UNITED STATES PATENT AND TRADEMARK OFFICE

APPLICATION NO.	FILING DATE	FIRST NAMED INVENTOR	ATTORNEY DOCKET NO.	CONFIRMATION NO.
10/814,246	04/01/2004	Takahiro Okuno	251363US2	6970
22850	7590	05/27/2005	EXAMINER	
OBLON, SPIVAK, MCCLELLAND, MAIER & NEUSTADT, P.C.			ARENA, ANDREW OWENS	
1940 DUKE STREET			ART UNIT	
ALEXANDRIA, VA 22314			PAPER NUMBER	
			2811

Office Action Summary

DETAILED ACTION

FIG. 13

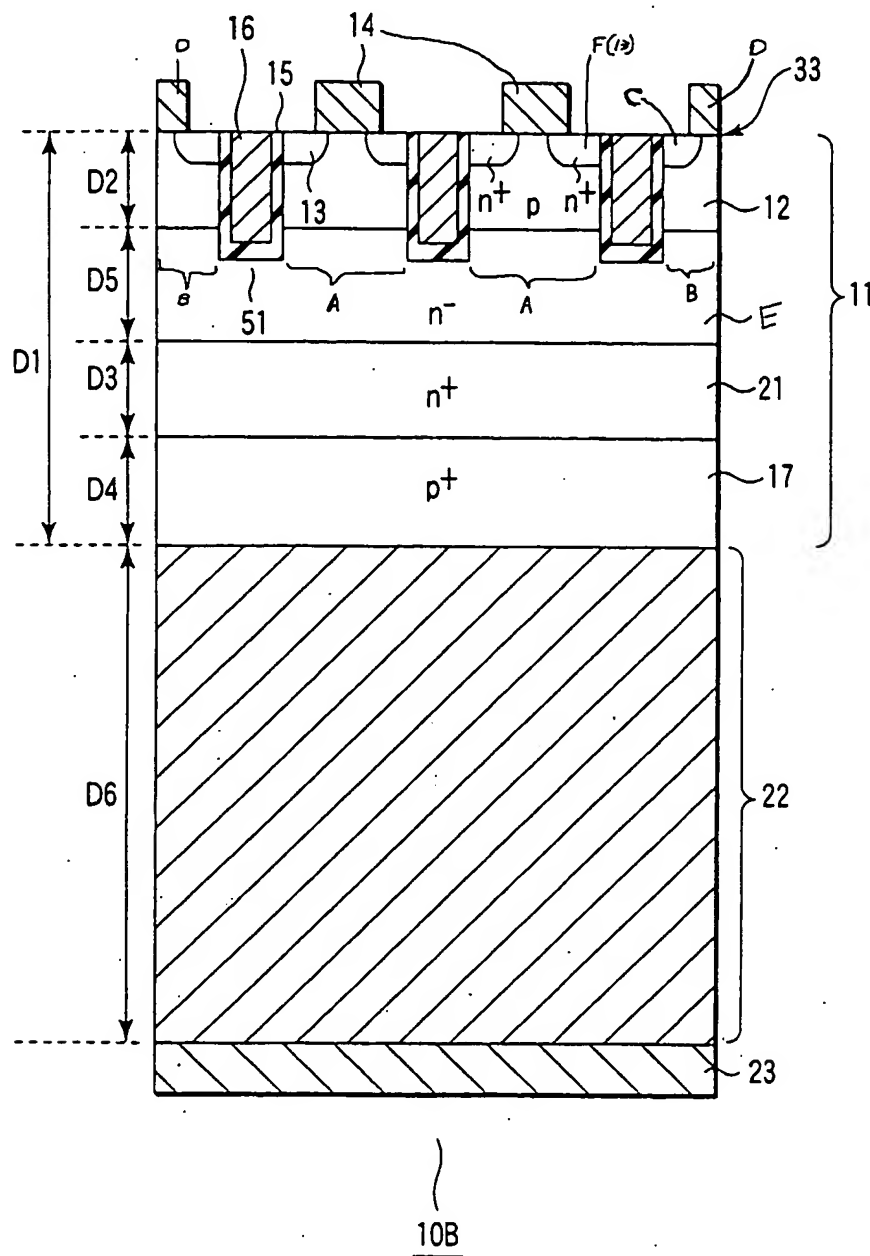
8. A copy of Fig. 13 from Tanaka is provided with additional references to clarify comparisons made by the examiner. The figure is identical to the original figure from

Tanaka, with the exception that six new reference labels have been added. The added reference labels have been given letter designations to distinguish them from the original numbered reference labels.

9. Regarding claims 1 and 8, Tanaka discloses a semiconductor device comprising:

a drift layer (E) of a first conductivity type;

a collector layer (17) of a second conductivity type located on the drift layer;

a collector electrode (22,23) located on the collector layer;

a base layer (12) of the second conductivity type located in a region isolated from the collector layer on the drift layer;

a plurality of trenches (51) formed at certain intervals to extend from the top surface of the base layer into the drift layer and thereby divide the base layer to main cell regions (A) and dummy cell regions (B);

a first emitter layer (13) of the first conductivity type selectively formed in the surface layer of the base layer in each main cell region to extend along adjacent one of the trenches;

gate electrodes (16) formed in the trenches sandwiching each main cell region among said plurality of trenches via a gate insulating film (15);

an emitter electrode (14) located over the base layer and the first emitter layer in each main cell region; and

a second emitter layer (C) of the first conductivity type selectively formed so as to be scattered in the surface layer of the base layer in each dummy region and having a surface area smaller than that of the first emitter layer. Note that Fig. 13 clearly shows second emitter layer (C) smaller than first emitter 13. With respect to this comparison, drawings may not be interpreted as providing exact dimensions, but may be interpreted to indicate relative sizes.

13. Regarding claims 4 and 12, it is known to one of ordinary skill in the art that the manufacture of semiconductor devices such as Tanaka's and the applicant's frequently results in a layout in which cross-sections like Tanaka's Fig. 13 or applicant's Fig. 2 are repeated in a lateral direction (for example, applicants Fig. 1). Therefore, each dummy

cell region (B) will have trenches on either side "wherein the second emitter layer is formed as isolated patterns in contact with the trenches opposed to each other via the base layer in each dummy cell region."

14. Regarding claims 6 and 11, Tanaka further discloses "a via contact (D) formed in contact with the second emitter layer (C) to connect the base layer (12) in the dummy cell region (B) to the emitter electrode (14) via the second emitter layer,"

17. Regarding claims 5 and 13, Tanaka discloses the semiconductor devices having the second emitter layer (D) formed as patterns in contact with the trenches (51) opposed to each other via the base layer in each dummy cell region.

18. Tanaka does not disclose "the second emitter layer is formed as island shaped patterns each having opposite ends in contact with the trenches."

19. However, such difference is regarded as nothing more than an obvious variation of Tanaka. Therefore, it would have been obvious to a person of ordinary skill in the art at the time of the invention to connect the isolated second emitter regions opposing one another in each dummy cell region to one another, forming a continuous island-pattern second emitter region with opposite ends in contact with the trenches opposed to each other.
